**CORNER GREEN RESIDENTS' SOCIETY LIMITED**

**EXTRAORDINARY GENERAL MEETING**

**THURSDAY 16<sup>TH</sup> MARCH 2023 at 7.30pm at 21 Corner Green**

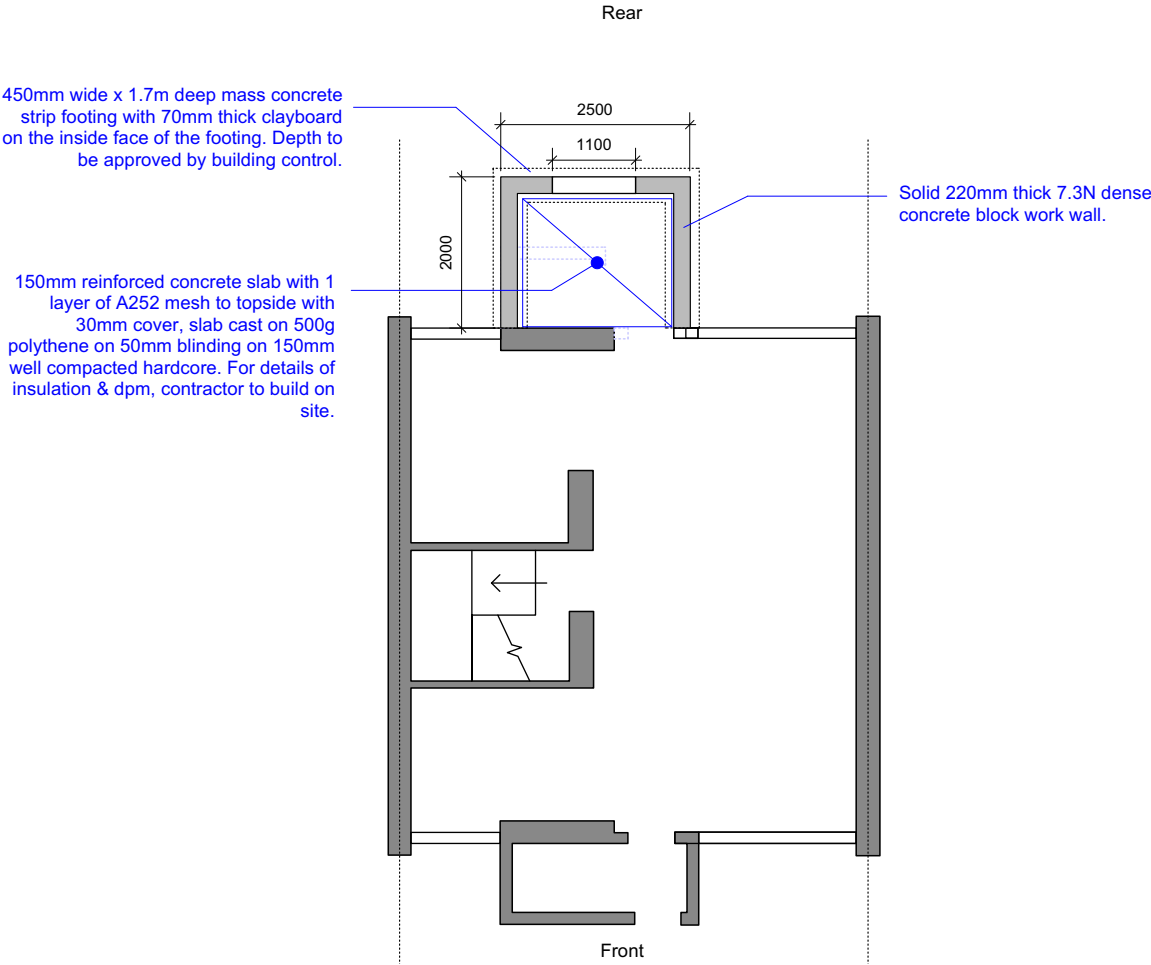
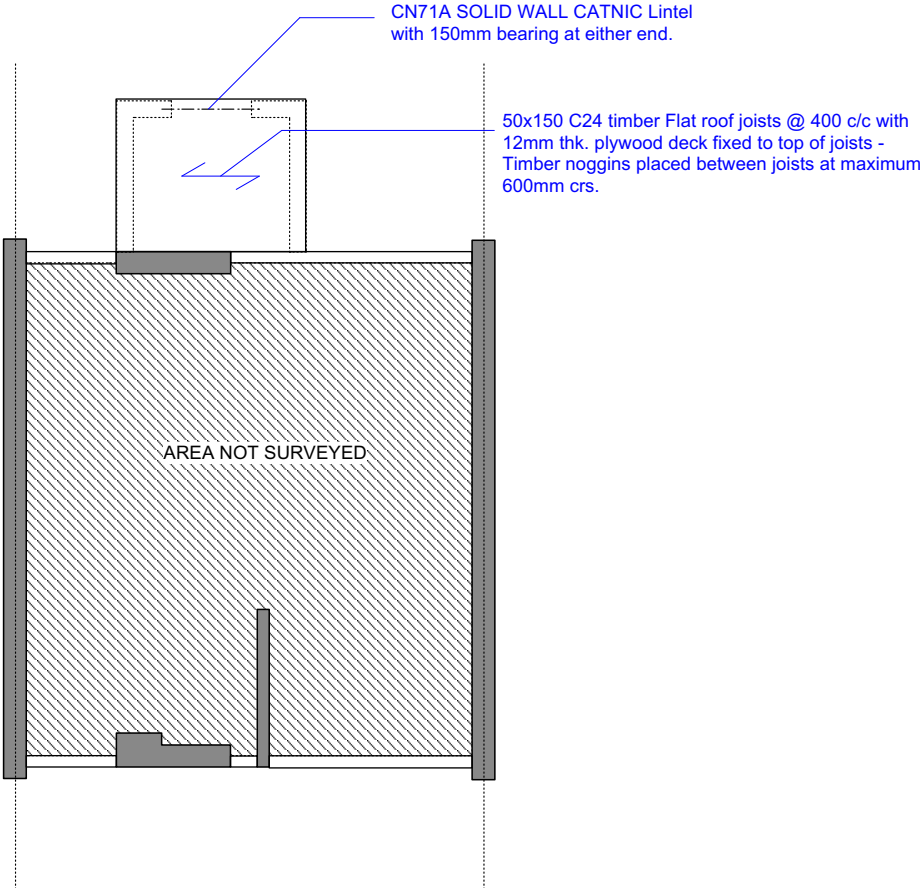
Subject	Action
<p><b>Extension 12:</b> Jane and Michael to present extension to no 12 for approval. Plans are included below.</p> <p>Discussion about dimensions and position. Under 20 m<sup>3</sup></p> <p>Conditions:</p> <ul style="list-style-type: none"><li>• The dimensions are as stated in the plans are not exceeded</li><li>• The external materials are as specified in the plans</li><li>• Construction work is only undertaken at the times permitted by BCER Ltd (Mon-Fri 8:00-18:00)</li><li>• Materials, skips or other plant or equipment associated with the construction are not stored on CGRS land without the Company's prior consent</li><li>• Contractors do not obstruct the rear access lane with their vehicles or materials</li><li>• Contractors do not play amplified music or other noise through radios or other device</li><li>• Contractors do not display any advertisement</li></ul> <p>Skip needs to be approved by directors</p> <p>Work to take ca. one month.</p>	Approved
